SUBJECT: INSPECTION REPORT NO. 70-143/2007-207

**U.S. NUCLEAR REGULATORY COMMISSION
OFFICE OF NUCLEAR MATERIAL SAFETY AND SAFEGUARDS**

Report No.: 70-143/2007-207

Licensee: Nuclear Fuel Services, Inc.

Figure 1
Glovebox Reflector Arrangement

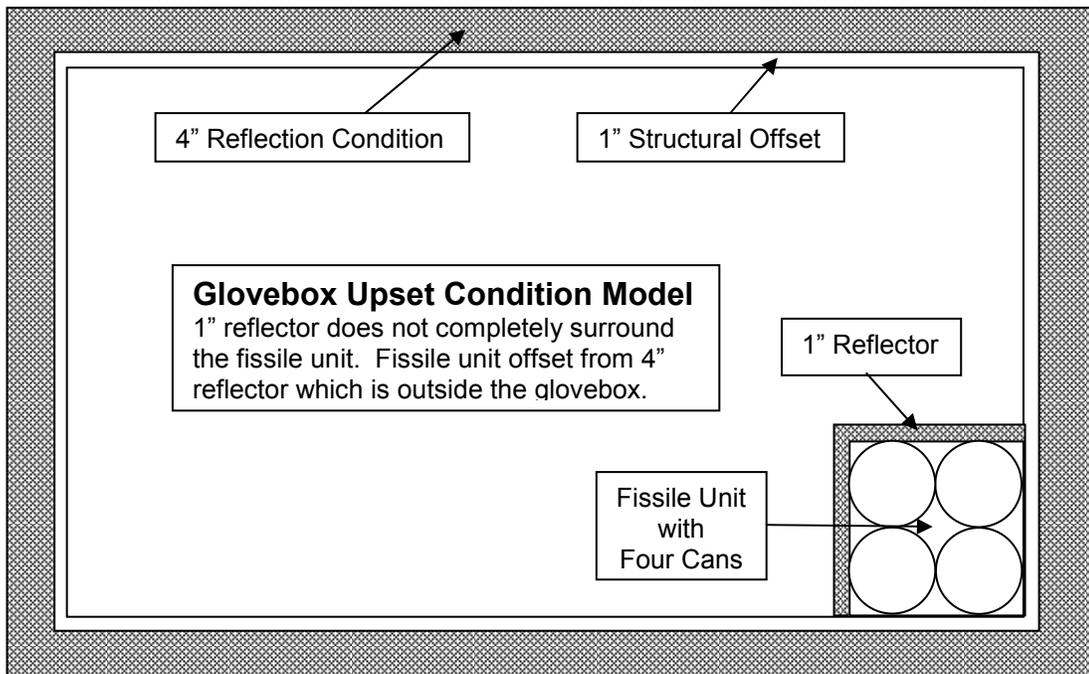
The license application specifically spells out when offset of the reflector is allowed. Offset of the reflector in computer calculations is limited to incidental reflection or, in Section 4.2.2.4, to interaction analyses. The inspectors noted that certain licensee calculations associated with gloveboxes contained computer models of fissile units with gaps between the reflector and the fissile unit (see Figure 1). Licensee NCS staff stated that, when a glovebox enclosure was relied on to maintain conditions of less than full reflection, the reflection condition can be modeled on the outside of the enclosure. The inspectors determined that the licensee NCS staff had intermingled requirements for less than full reflection with requirements for incidental reflection.

The inspectors determined that less than full reflection conditions were required to be modeled with a tight fitting layer around the fissile unit. In the glovebox cases, the enclosure is maintaining the conditions around the fissile unit but is not the outer boundary for the fissile unit and should not be used to offset the reflection condition. Therefore, the model shown in Figure 1 would require the one-inch reflector to completely surround the fissile unit if the model was used to demonstrate double contingency, subcritical margin, or performance requirements for an accident sequence leading to criticality.

Licensee NCS staff stated their belief during the inspection that tight fitting reflector conditions were not required for less than full reflection models. The inspectors reviewed a sampling of analyses and noted that, in every case with gaps in a glovebox model, the licensee had complementary models without gaps and that these tight fitting reflector models were situated in the corner of the glovebox so that two of the walls were more than 1-inch thick. Therefore, the inspectors did not identify an example of a

computer model with gaps in the reflector being used to establish compliance. The inspectors noted that the license requirements regarding reflection were complex and would require further review relative to the licensee models. The inspectors also noted that the combination of tight fitting and offset reflectors normally used in licensee models were relatively conservative and no immediate safety concern was identified. The licensee use of gapped reflector models of fissile systems is **Unresolved Item (URI) 70-143/2007-207-01**.
